1765 MONTREAL ROAD

URBAN DESIGN BRIEF

Submitted for Zoning By-Law amendment  
10 April 2025

Original design as submitted for SPA 2022-12-23 (D07-12-22-0185)

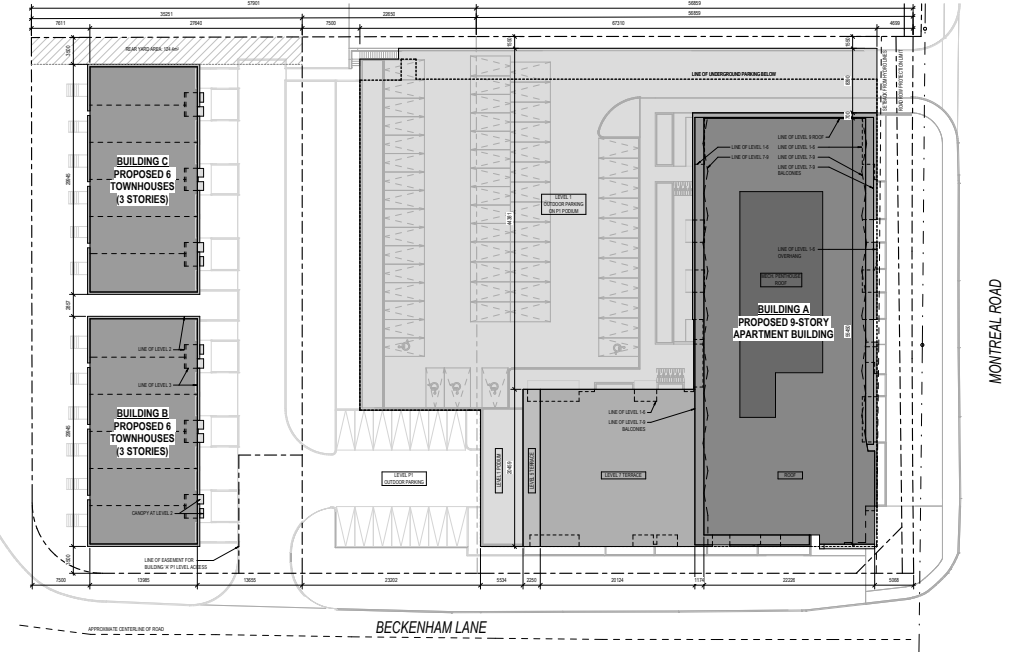
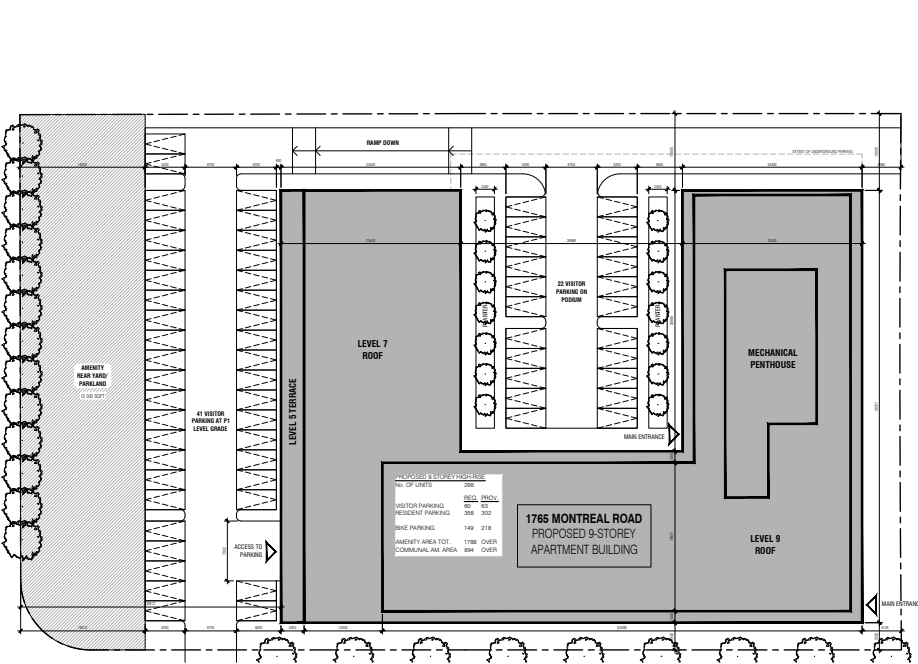
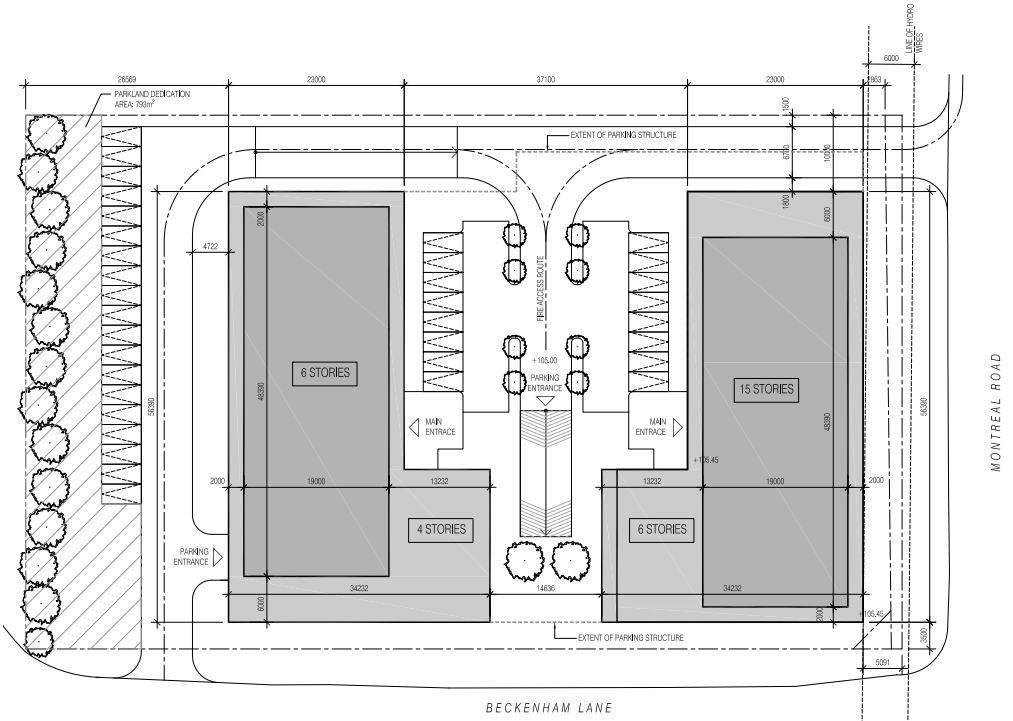
- *This project is within the City's Design Priority Area and will attend the UDRP.*  
Noted.
- *We recommend providing a main entrance on Montreal Road. The previous entrance was at the intersection corner and appeared well-considered.*  
The current proposal features a main entrance at the corner of Montreal and Beckenham.
- *We recommend the interior courtyard be designed as an amenity space, not a parking lot.*  
We will add planting and landscaping as required to make the interior court feel like a meeting place instead of a parking lot.
- *We recommend limiting the tower floorplate to a maximum of 750m².*  
We will respect the recommended 750m² floor plate area for the tower portion of the 17-story building

- *We recommend additional analysis to illustrate how the transition is provided to the neighboring property to the northeast.*  
Since the proposed development is 17 storeys, we are mindful that it represents an increase in density in the area, and a number of measures have been used to assist with the transitioning of the building to the surrounding properties.

- *We recommend limiting the height of this building to four stories to align with the surrounding low-rise neighborhood condition and keeping the mid-rise built form (AM zone) closer to the Montreal Road corridor.*  
The area of the side closest to the low-rise development on Cedar does not feature any development. Instead, this area will be used as a landscape buffer, parkland area, and 9 parking spaces. The northern building is located approximately 26 m from the northern property line. The majority of the development is considered mid-rise with sections at 5 and 7 storeys, and a 700 m2 floorplate area that extends up to 17 storeys. The densest portion of the development is closest to the Montreal Road corridor.

**Measure 1** - Height of Building on Montreal Road: the proposed development has pushed the highest portion of the apartment building as close to Montreal Road, and the southern end of the lot as possible. This helps the building appropriately respond to the bigger and faster scale of Montreal Road, while helping reduce shadows cast by the building on neighbouring properties.

**Measure 2** - Stepping Down of Apartment Building: the apartment building steps down towards Cedar Road at level 7, providing a communal terrace with views towards the Ottawa River, and again at level 5. This stepping down of the built form helps to transition the heavier mass towards the lower density residential buildings of the neighbourhood to the north.

**Measure 3** - Tree Conservation: the existing tree cover along the property line on Cedar road helps to buffer this transition in height.
